**ADDENDUM No. 1
DOCUMENT 00 91 13-A**

DATE: OCTOBER 11, 2024

**PROJECT: RENOVATION OF DISTRICT 7 WELCOME CENTERS, IN
PIKE & WILKINSON COUNTIES**

**PROJECT NUMBER: BWO-7124-57(003) / 503755-303000
BWO-7135-79(003) / 503755-304000**

PIKE WELCOME CENTER FLOOR PLAN
3/16" = 1'-0"

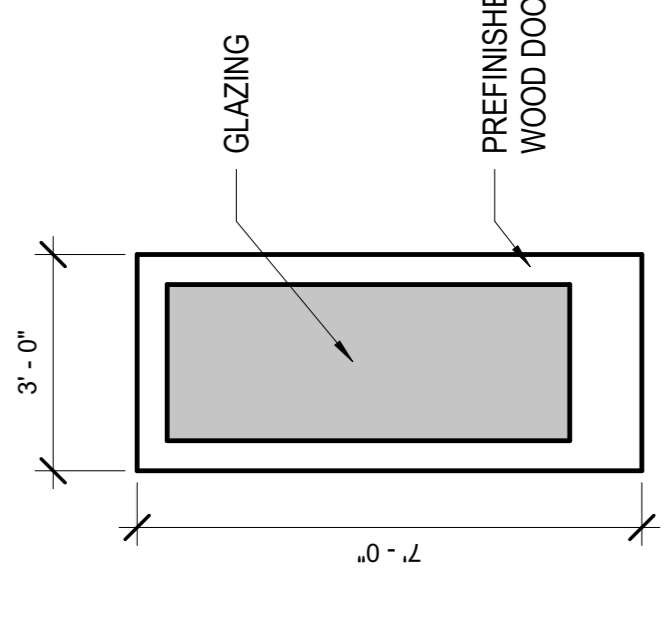
- A. Added Sheet No. 1 – Sheet Index
- B. Sheet No. 2, Pike Notes 1,3,4,6,12,17,18,19 revised 10-4-24, see revisions.
- C. Sheet No. 2, Pike Notes – Note 14 – delete the existing note and replace with **“Install two (2) pet waste stations, to be supplied by Owner. Dig a post hole 24 inches deep, install post in concrete, install waste can on post, 6 inches off ground, install dispenser and sign on post. Follow the manufacturer's installation instructions.**
- D. Sheet No. 3, Wilkinson Notes 3,4,6,12,13 revised 10-4-24, see revisions.
- E. Sheet No. 2, Wilkinson Notes – Note 11 – delete the existing note and replace with **“Install two (2) pet waste stations, to be supplied by Owner. Dig a post hole 24 inches deep, install post in concrete, install waste can on post, 6 inches off ground, install dispenser and sign on post. Follow the manufacturer's installation instructions.**

- 1 REMOVE EXISTING DOOR AND REPLACE WITH NEW FIBERGLASS DOOR AND HARDWARE. SEE SPECIFICATION.
- 2 REMOVE CURTAIN RODS AND PATCH HOLES.
- 3 REPLACE DRINKING FOUNTAINS. (OWNER FURNISHED). REMOVE SOLID SURFACE BACKSLASH. PATCH AND REPAIR BRICK AS REQUIRED PRIOR TO PAINTING.

- 4 PAINT ALL EXISTING WOOD AND FIBERGLASS DOORS. REMOVE HARDWARE. CLEAN, AND REUSE. SAND, PRIME, AND PAINT EXISTING DOOR. SEE SPECIFICATION. REINSTALL DOOR AND HARDWARE.

- 5 REMOVE BULLETIN BOARD AND PATCH HOLES.
- 6 PRESSURE WASH EXTERIOR OF BUILDING, INCLUDING PORCH FLOOR. TAKE CARE NOT TO DAMAGE SURFACES. COMPLETELY REMOVE ALL MOLD, MILDEW, AND OTHER FOREIGN SUBSTANCES.

- 12 PRESSURE WASH PICNIC PAVILIONS AND GUARD HOUSE. PAINT ALL PREVIOUSLY PAINTED INTERIOR AND EXTERIOR SURFACES.
- 13 INSTALL NEW LITERATURE RACKS AS DIRECTED. (OWNER FURNISHED)

- 14 INSTALL PETWAY STATIONS AS DIRECTED. (OWNER FURNISHED)
- 15 REMOVE EXISTING WALL MOUNTED TV AND MOUNT AS DIRECTED. REMOVE UNUSED SURFACE MOUNTED TV CABLES AS DIRECTED. PATCH HOLES PRIOR TO PAINTING.

- 16 ALL SALVAGE ITEMS TO BE REMOVED CAREFULLY AND RETURNED TO OWNER.
- 17 REPLACE EXISTING HANDWASHING STATION (4 IN TOTAL) WITH BRADLEY GLX-2 WITH VERGE METRO FAUCETS OR APPROVED EQUAL. FAUCET SENSORS TO BE CONNECTED TO HOUSE POWER. SUBMIT PRODUCT DATA FOR REVIEW.

- 18 REPLACE FOUR (4) HAND DRYERS (PER RESTROOM) WITH BRADLEY MODEL 2823-28W001 OR APPROVED EQUAL.
- 19 REPLACE FOUR (4) 24" X 36" MIRRORS (PER RESTROOM) WITH BRADLEY MODEL 781 OR APPROVED EQUAL.
